Duke Power Company
Catawba Nuclear Station

Fuel Enrichment Upgrade

License Amendment Request
and
Supporting Safety Analysis

Table 3.9-1

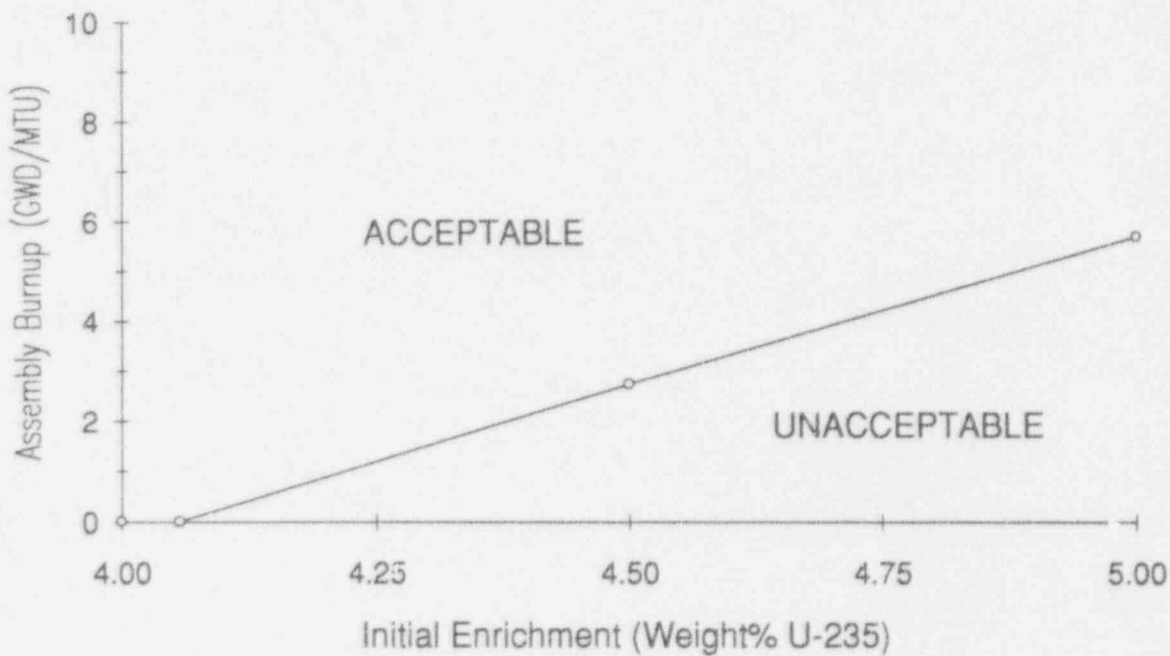
*add to
Section
3/4.9.13*

Initial Enrichment Weight% U-235	Assembly Burnup (GWD/MTU)
4.05 (or less)	0
4.50	2.73
5.00	5.67

Table 3.9-2

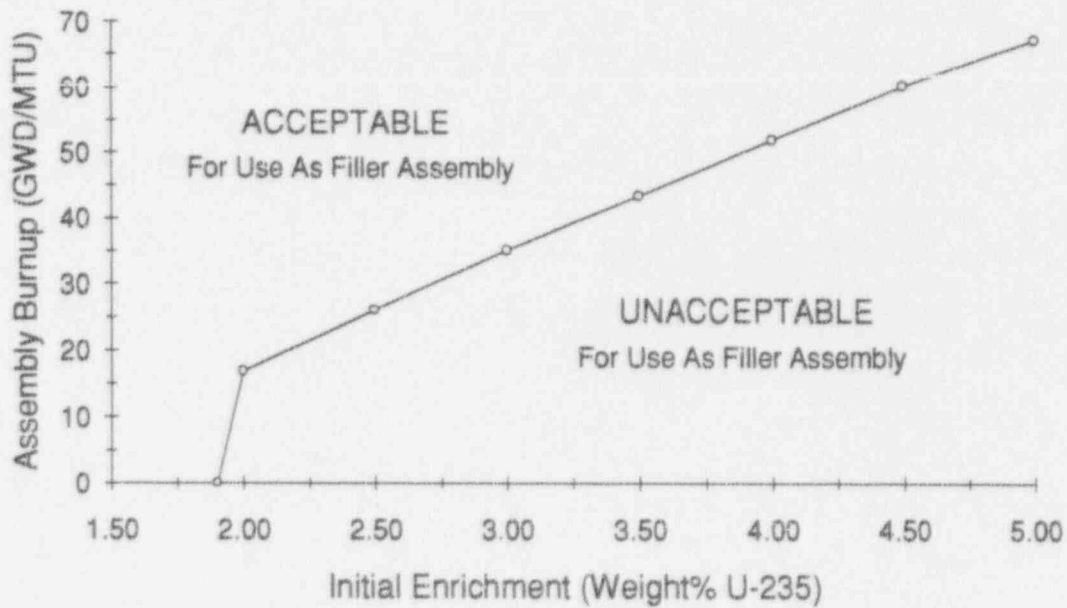
*add to
Section
3/4 9.13*

<u>Initial Enrichment</u> <u>Weight% U-235</u>	<u>Assembly Burnup</u> <u>(GWD/MTU)</u>
1.90 (or less)	0
2.00	16.83
2.50	26.05
3.00	35.11
3.50	43.48
4.00	51.99
4.50	60.36
5.00	67.28

Figure 3.9-1
Required 3 out of 4 Loading Pattern
for Restricted Storage

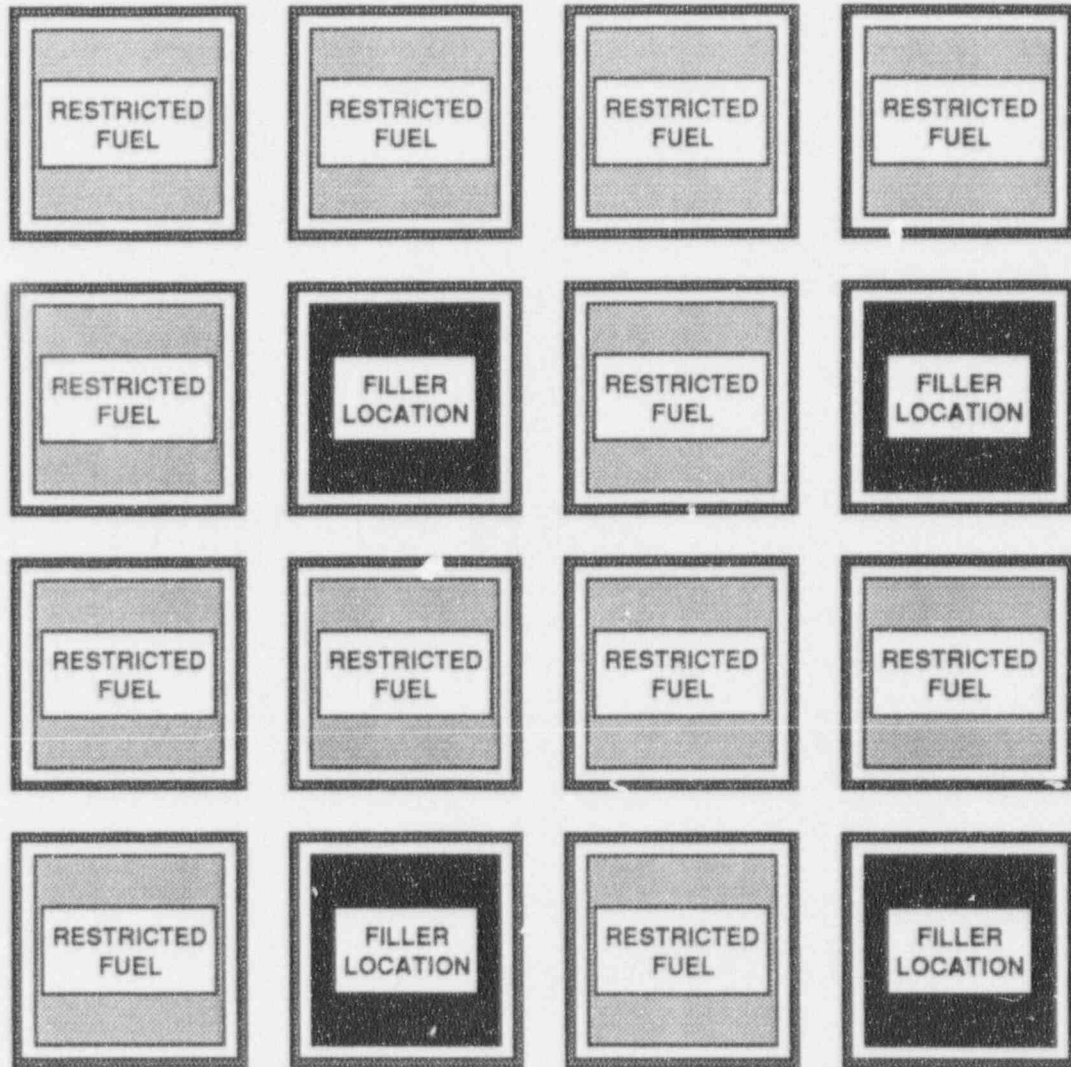
*add to
Section
3/4.9.13*

Restricted Fuel: Fuel which does not meet the minimum burnup requirements of Table 3.9-1. (Fuel which does meet the requirements of Table 3.9-1 may be placed in restricted fuel locations as needed)

Filler Location: Either fuel which meets the minimum burnup requirements of Table 3.9-2, or an empty cell.

Boundary Condition: Any row bounded by an Unrestricted Storage Area shall contain a combination of restricted fuel assemblies and filler locations arranged such that no restricted fuel assemblies are adjacent to each other.
Example: In the figure above, row 1 or column 1 can not be adjacent to an Unrestricted Storage Area, but row 4 or column 4 can be.

Figure 7-1
Catawba Spent Fuel Pool Storage Curves

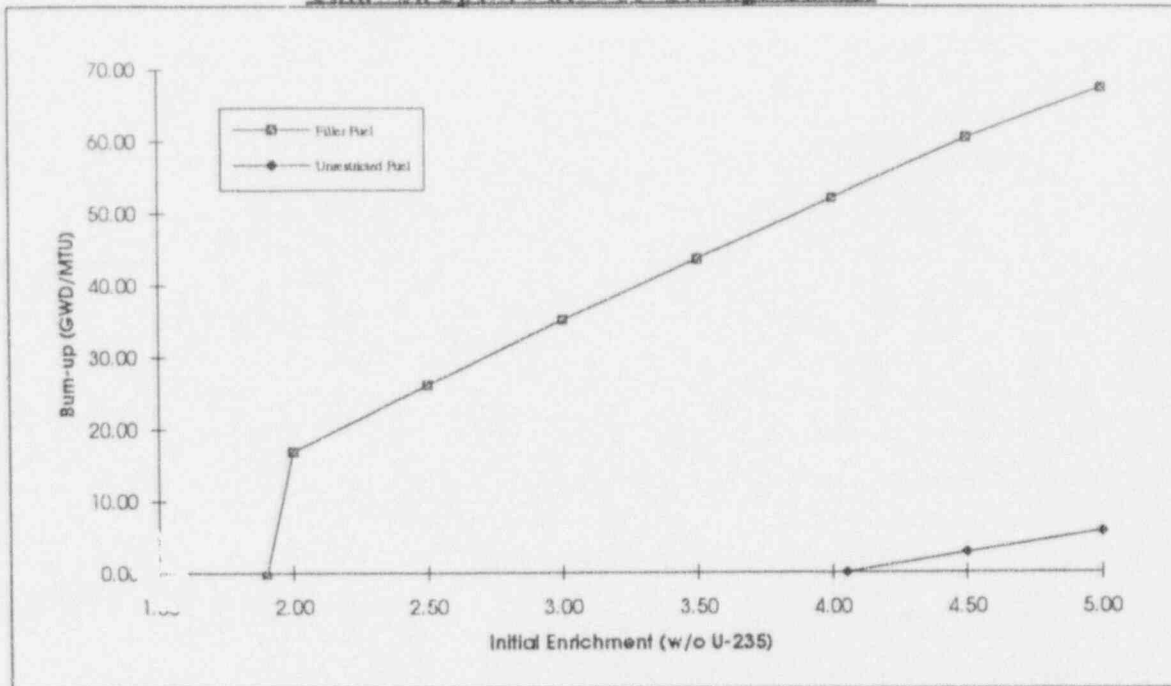
The burnup credit criticality analysis results are summarized by the two burnup curves shown in figure 7-1. These curves define the burnup requirements for the two fuel loading configurations allowed in the Catawba spent fuel pools. Specific data points generated by the criticality analysis and used to create these burnup curves are shown in Table 7-1.

Unrestricted Fuel	Minimum requirements for unrestricted (100%) fuel storage. Assemblies not meeting 100% storage requirements must be stored in a 75% loading pattern with qualified filler assemblies or empty cells
Filler Fuel	Minimum requirements for filler assemblies

Figure 3.9-1

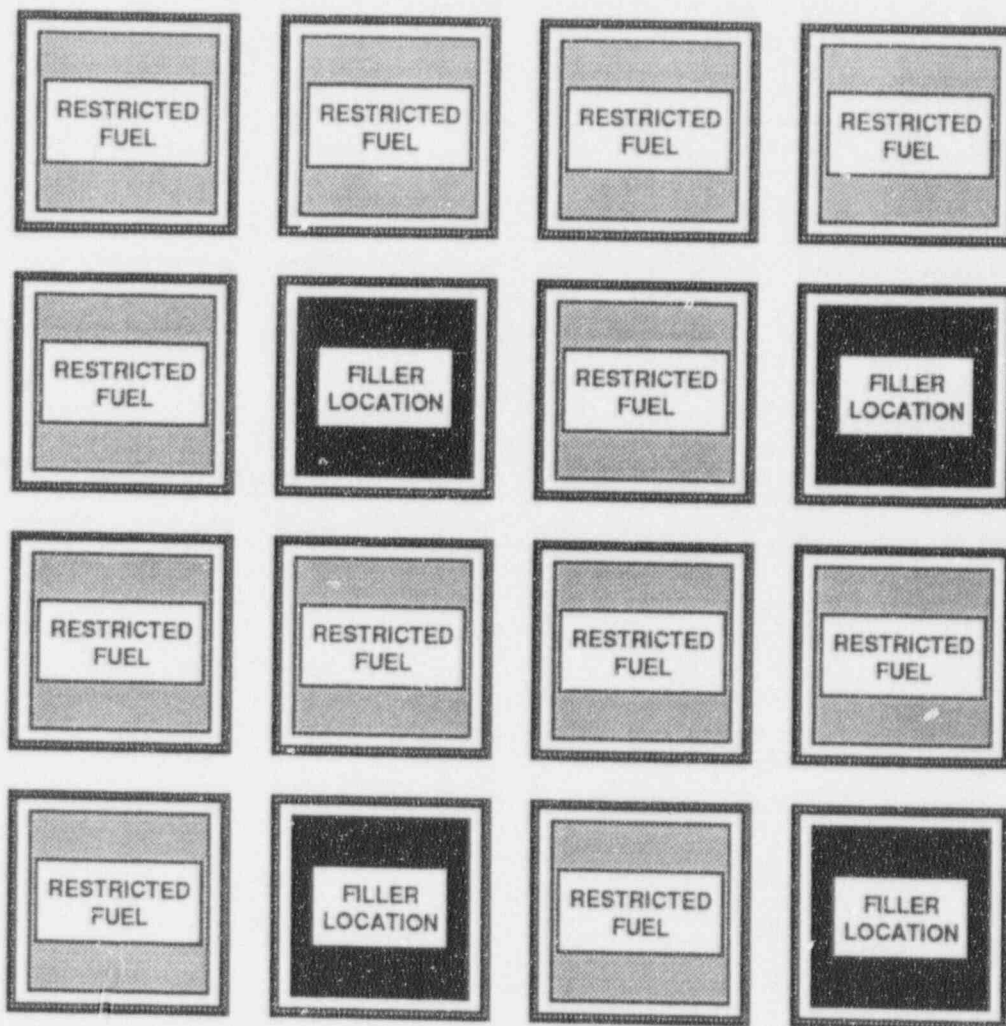
Required 3 out of 4 Loading Pattern
for Restricted Storage

- Restricted Fuel: Fuel which does not meet the minimum burnup requirements of Table 3.9-1. (Fuel which does meet the requirements of Table 3.9-1 may be placed in restricted fuel locations as needed)
- Filler Location: Either fuel which meets the minimum burnup requirements of Table 3.9-2, or an empty cell.
- Boundary Condition: Any row bounded by an Unrestricted Storage Area shall contain a combination of restricted fuel assemblies and filler locations arranged such that no restricted fuel assemblies are adjacent to each other
Example: In the figure above, row 1 or column 1 can not be adjacent to an Unrestricted Storage Area, but row 4 or column 4 can be.
